## SERVICE INFORMATION BULLETIN

**APPLICABILITY:** 2015-2017MY WRX  
 2014-2017MY Forester Turbo

**NUMBER:** 07-133-18  
**DATE:** 02/09/18

**SUBJECT:** Knock Sensor Design Change, DTCs P0327, P0328, P0332 and P0333

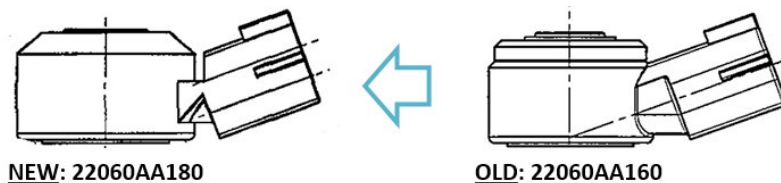
This Service Information Bulletin announces design changes to the engine's knock sensor which will help improve vehicle assembly line efficiency and increase durability. In some cases, the Check Engine light may illuminate and a knock sensor-related DTC set in the ECM memory: P0327, P0328, P0332 and P0333.

The part number for the new knock sensor is: **22060AA180**. The illustration below shows the difference between the new and the old part.

The new sensor was incorporated into production November 18<sup>th</sup>, 2016 starting with the following VINs:

- WRX: **H\*830255**
- Forester Turbo: **H\*523310**
